SUBJECT: ADDENDUM # 3

PROJECT TITLE: MEP Renovations to Earl Hall, SCSU

PROJECT NO.: **BI-RS-248**

MEP RENOVATIONS - EARL HALL
SOUTHERN CONNECTICUT STATE UNIVERSITY
NEW HAVEN, CONNECTICUT
PROJECT: BI-RS-248

DRAWING NO: SK-M1

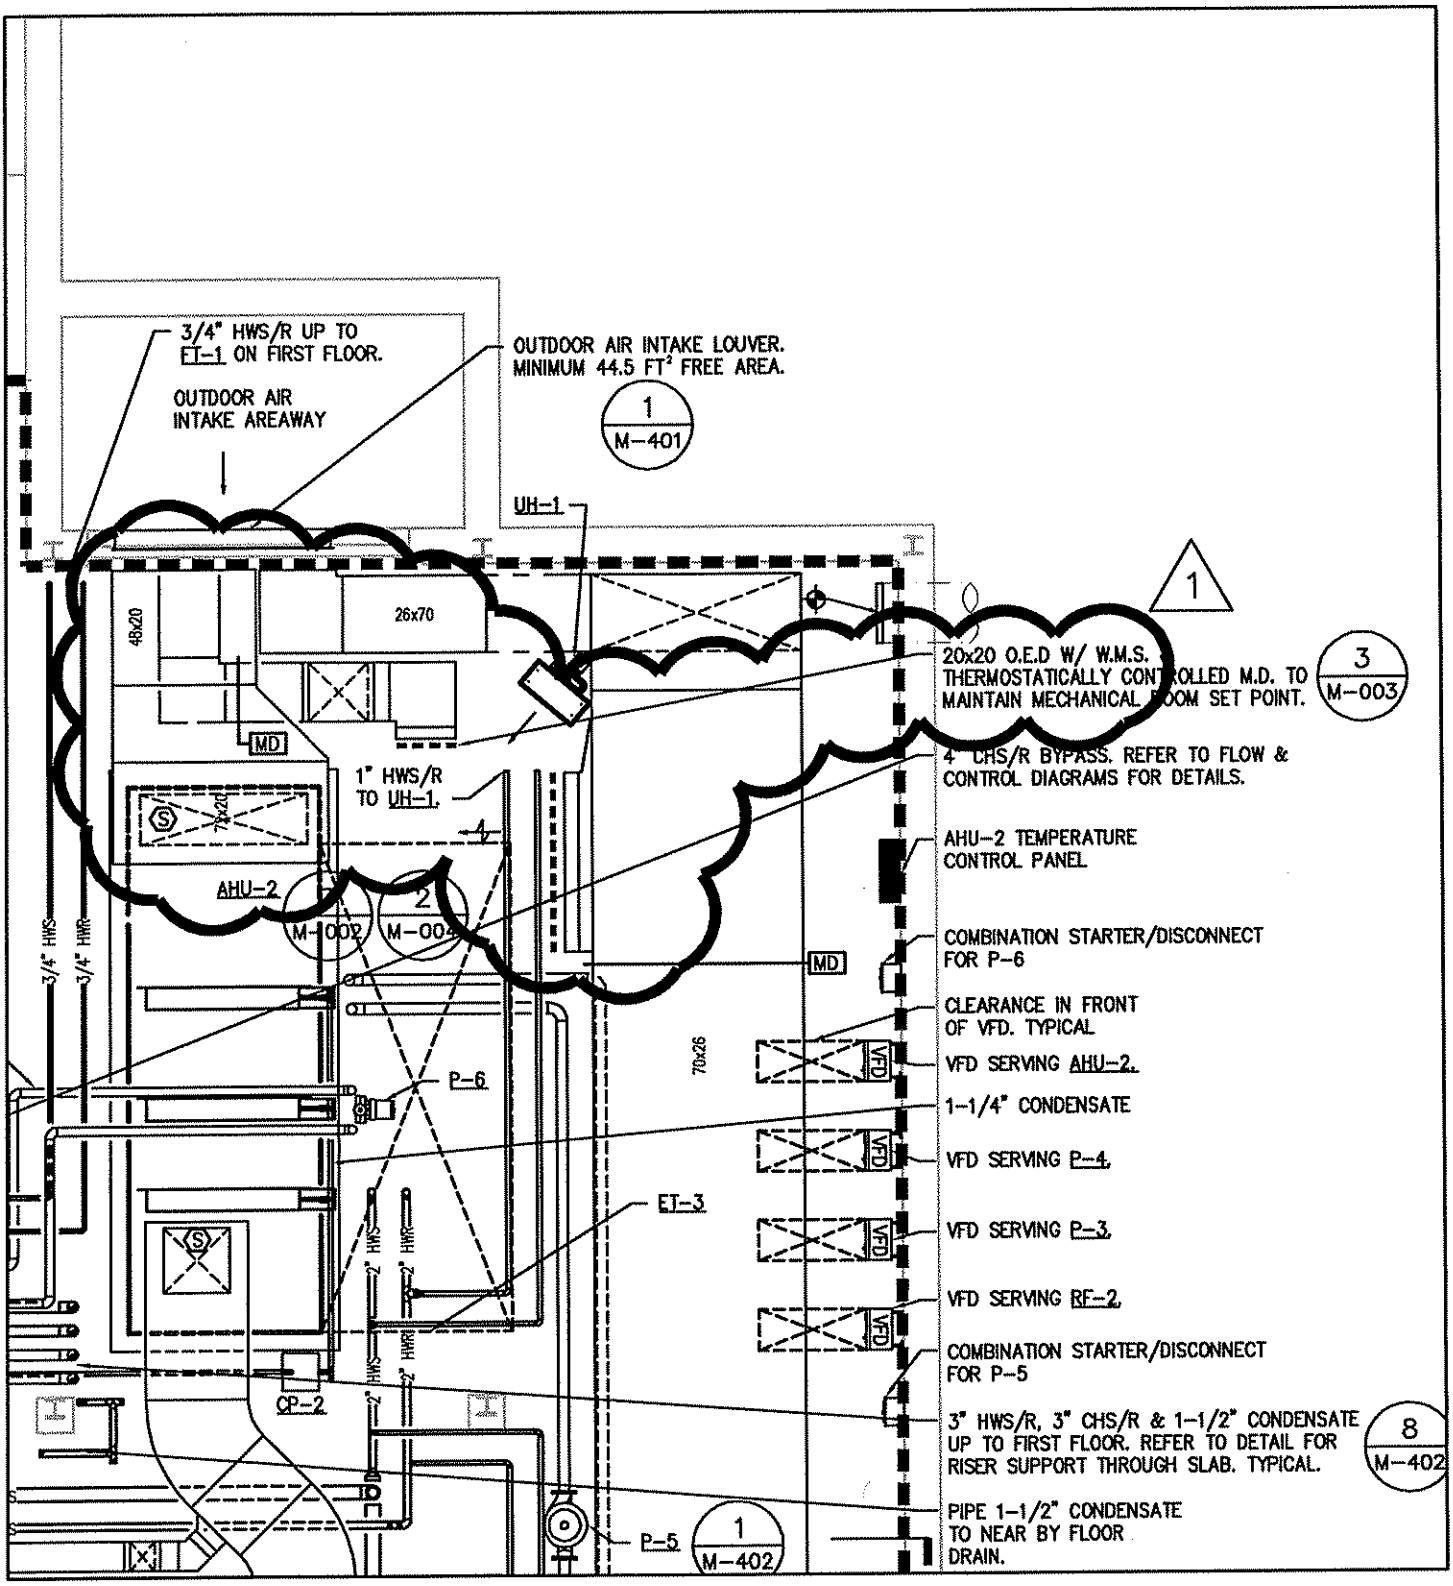
Item 9
DRAWING: M-200

Revised the outdoor air duct connection to the outdoor air intake louver. Refer to mechanical sketch SK-M1.

DRAWING NO:
SK-M2

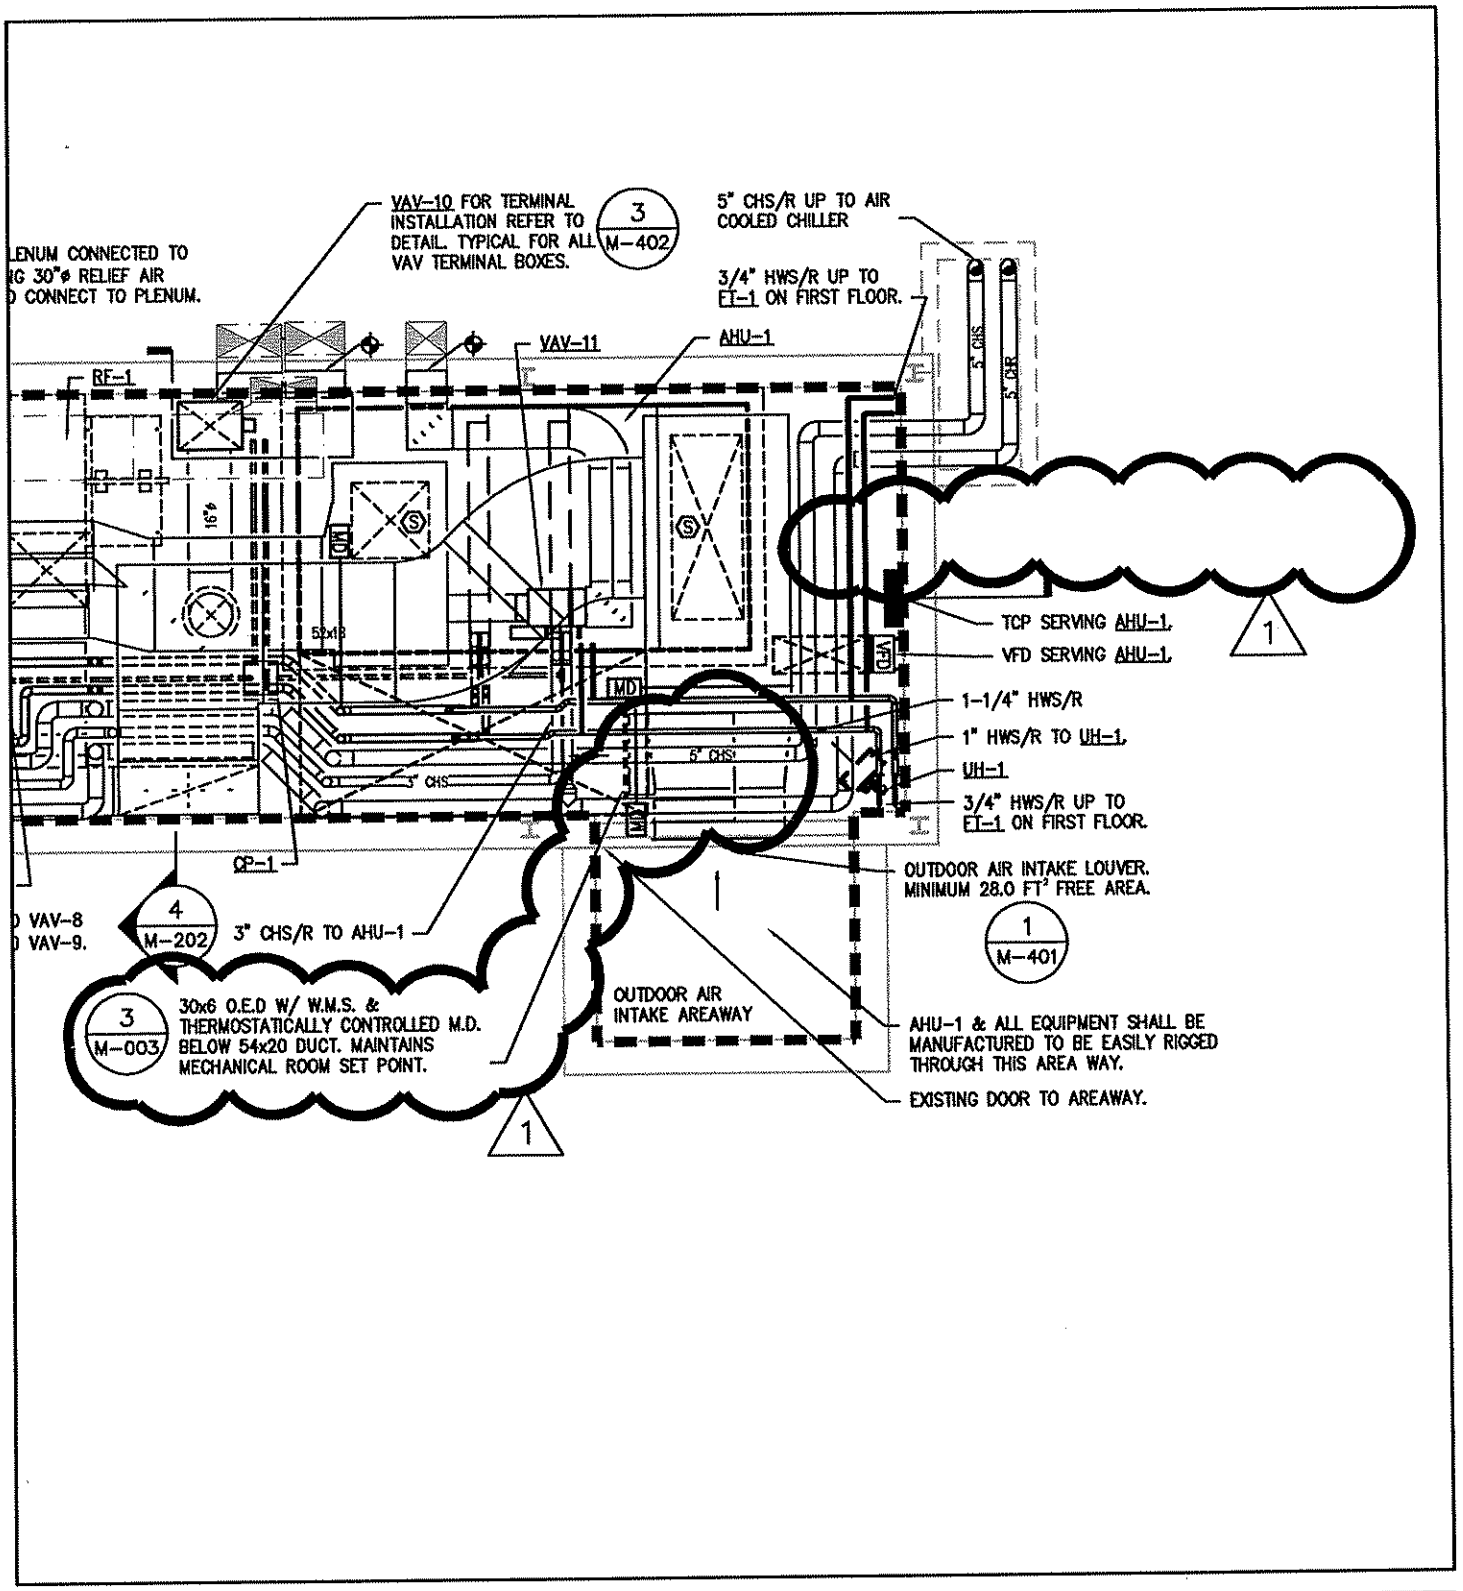
Item 10
DRAWING: M-201

Revised the outdoor air duct connection to the outdoor air intake louver. Refer to mechanical sketch SK-M2.

DRAWING NO:
SKP-1
DATE: 12-11-09
SCALE: NONE

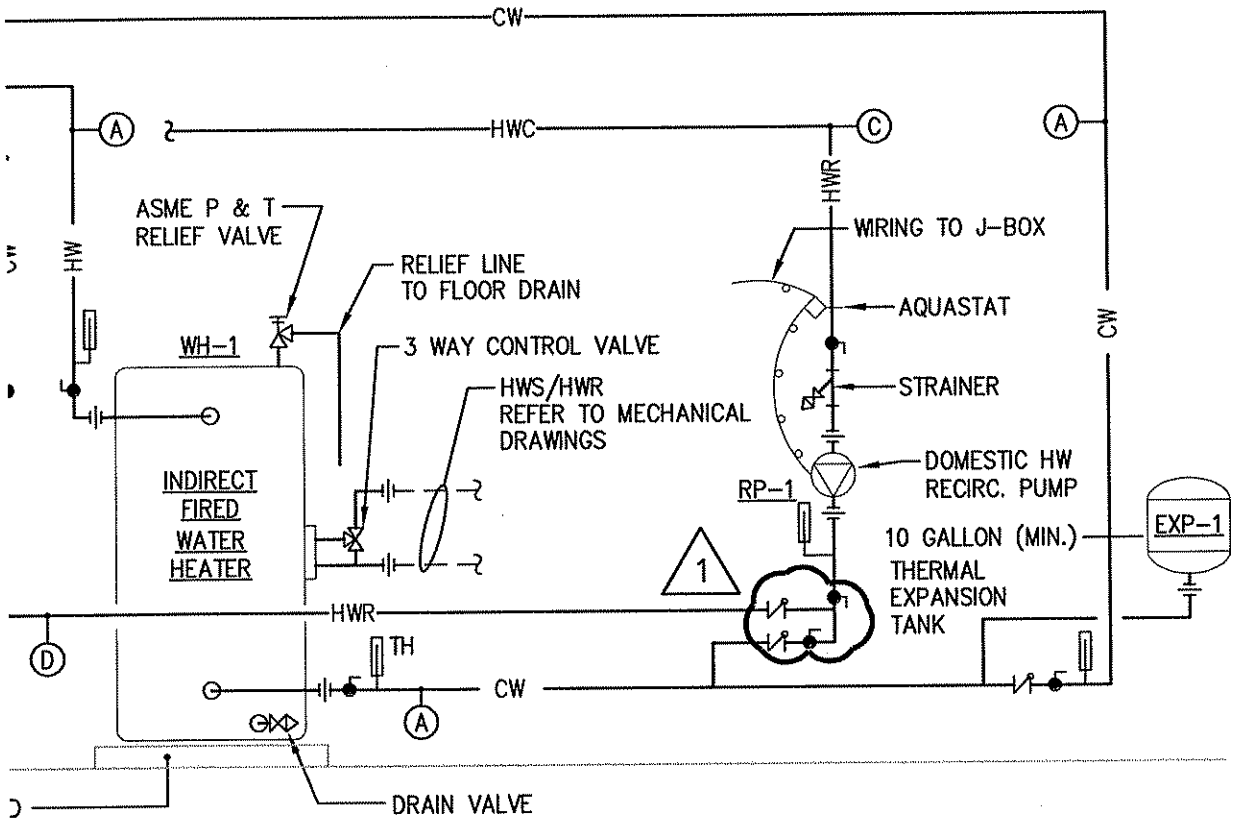
Item 8
DRAWING: P-201 Detail 2: Water Heater Piping Diagram

Revised the detail. Refer to SKP-1.

DRAWING NO:
SK-A1
DATE: 12-10-09
SCALE: AS NOTED

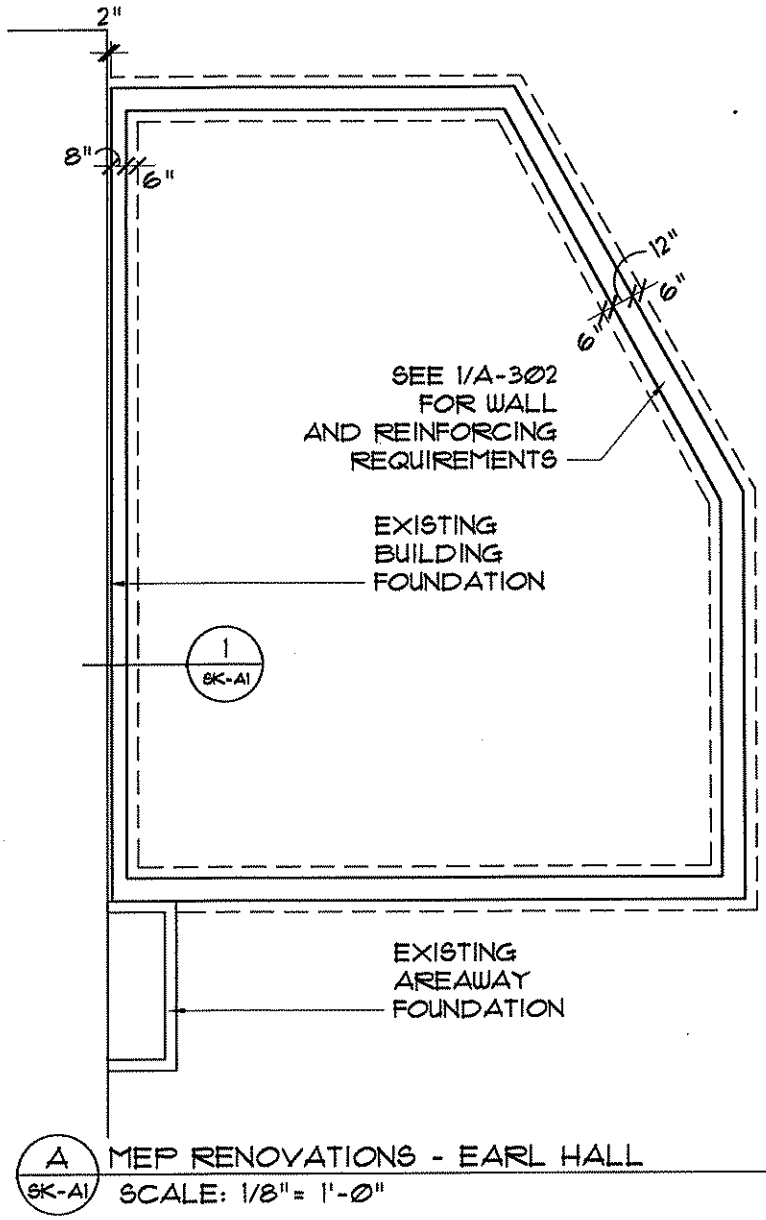
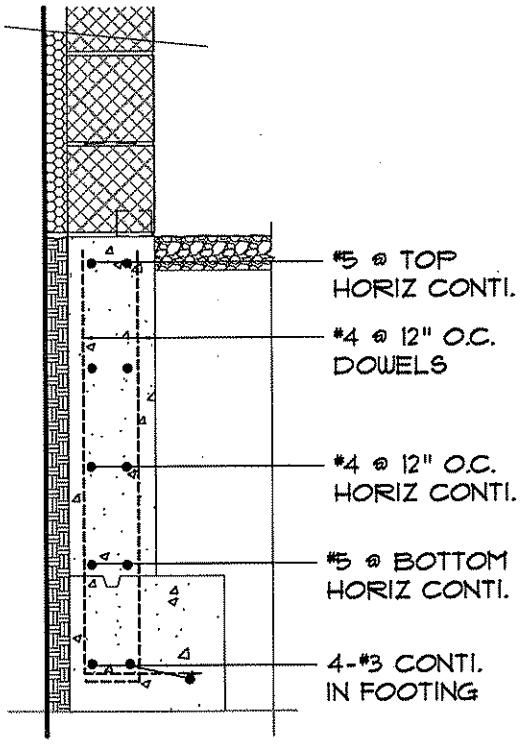
Can you please confirm the foundation requirements at the chiller enclosure as illustrated on 7/a-302 along the existing building. The section only addresses the CMU wall, not the concrete. It doesn't seem likely that a foundation already exists in this area.

ANSWER:
Please see attached SK-A1 for foundation requirements for the chiller enclosure.

DRAWING NO:
SKF-1
DATE: 12-11-09
SCALE: 3/32"=1'-0"

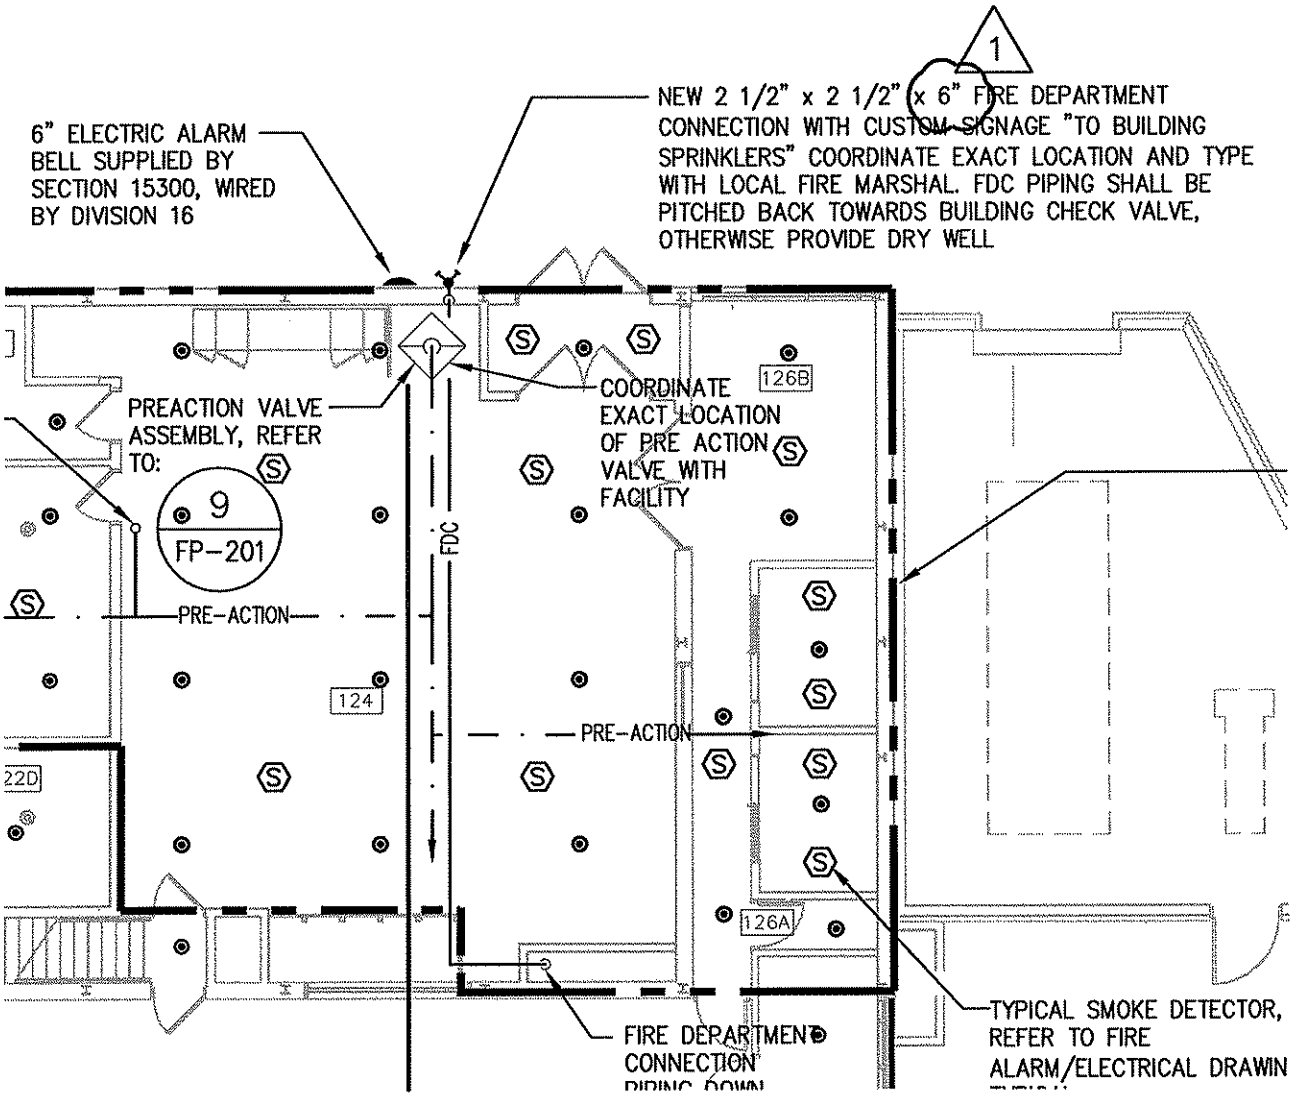
Request: The above referenced drawings show conflicting information for the proposed Fire Department Connection. Sheet 100 specifies 6-inch piping and FDC whereas FP-101 calls for a 4-inch FDC and piping. Please Clarify.

ANSWER:
The fire department connection shall be 6", the drawings shall be revised accordingly. Refer to fire protection sketch SKF-1.
